E/ECE/324
E/ECE/TRANS/505 } Rev.1/Add.68/Amend.1

Addendum 68: Regulation No. 69

Amendment 1

UNIFORM PROVISIONS CONCERNING THE APPROVAL OF REAR MARKING PLATES FOR SLOW-MOVING VEHICLES (BY CONSTRUCTION) AND THEIR TRAILERS

ARRANGEMENT OF THE APPROVAL MARK

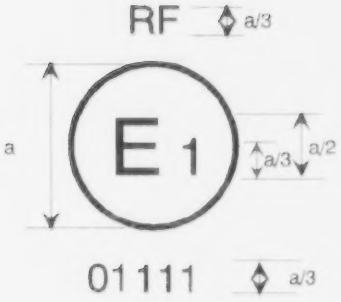
Annex 3, amend to read:

a = 5 mm min.

The SMV rear marking plate bearing the above approval mark has been approved in Germany (E1) under approval number 01111. The first two digits of the approval number indicate that the approval was granted in accordance with the requirements of this Regulation as amended by the 01 series of amendments. Symbol "RF" indicates class 1 SMV rear marking plate (retro-reflective/fluorescent materials). Class 2 (retro-reflective only materials) SMV rear marking plates shall be marked by symbol "RR".

Note: The approval number and the additional symbol must be placed close to the circle and either above or below the letter "E" or to the left or right of that letter. The digits of the approval number must be on the same side of the letter "E" and face in the same direction. The approval number and the additional symbol must be placed diametrically opposite one another. The use of Roman numerals as approval numbers should be avoided so as to prevent any confusion with other symbols.

Figure 1

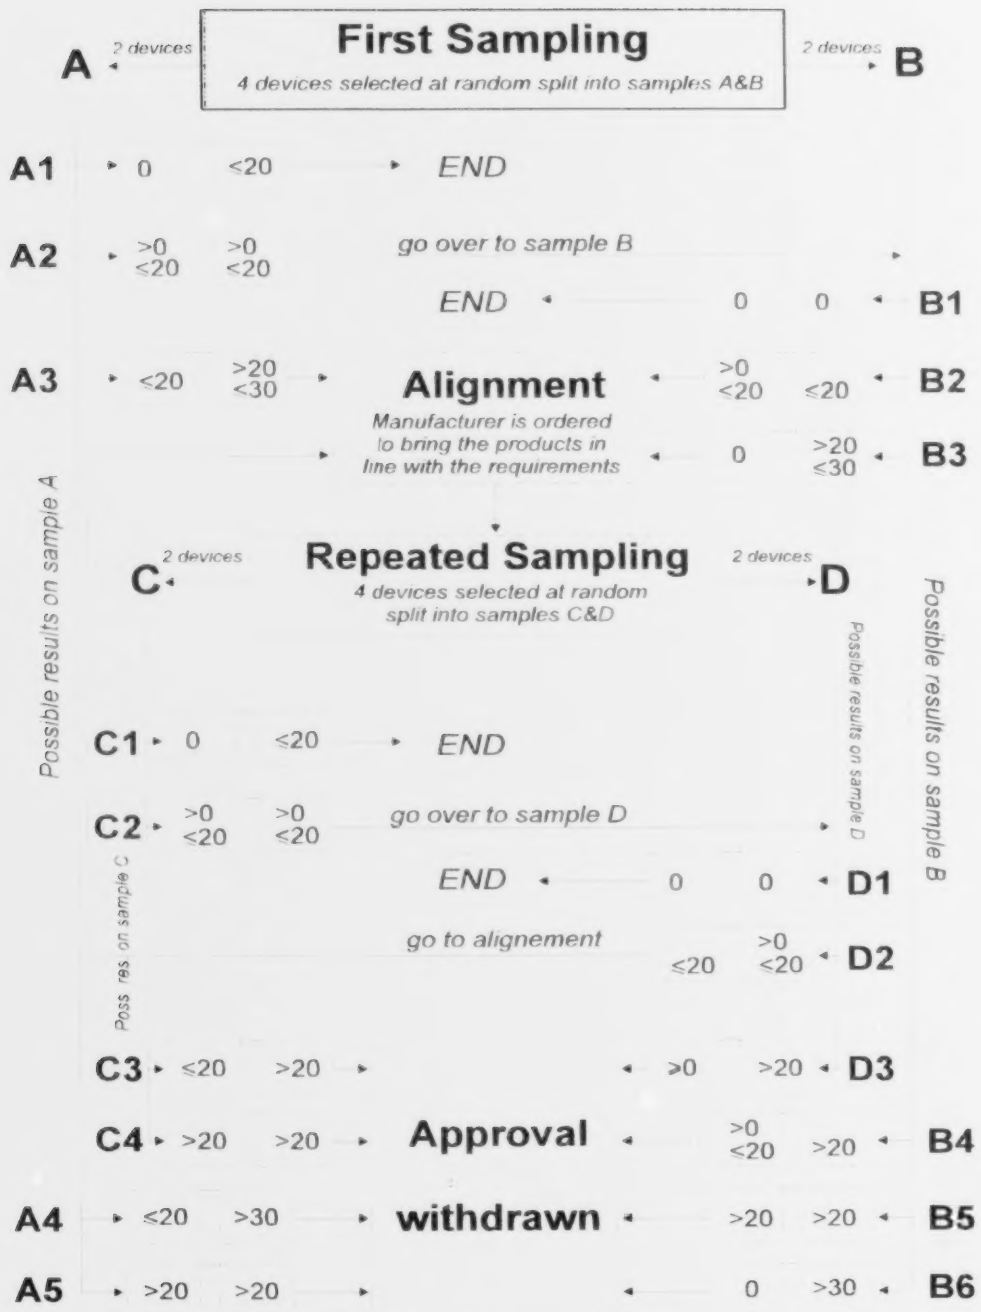
Add new annexes 13 and 14, to read:

2.1.1. Following the sampling procedure shown in Figure 1 of this annex the conformity of mass-produced rear marking plates shall not be contested if the deviation of the measured values of the rear marking plates in the unfavourable directions are:

2.2.1. Following the sampling procedure shown in Figure 1 of this annex the conformity of mass-produced rear marking plates shall be contested and the manufacturer requested to make his production meet the requirements (alignment) if the deviations of the measured values of the rear marking plates are:

Conformity shall be contested and paragraph 10 applied if, following the sampling procedure in Figure 1 of this annex, the deviations of the measured values of the rear marking plates are:
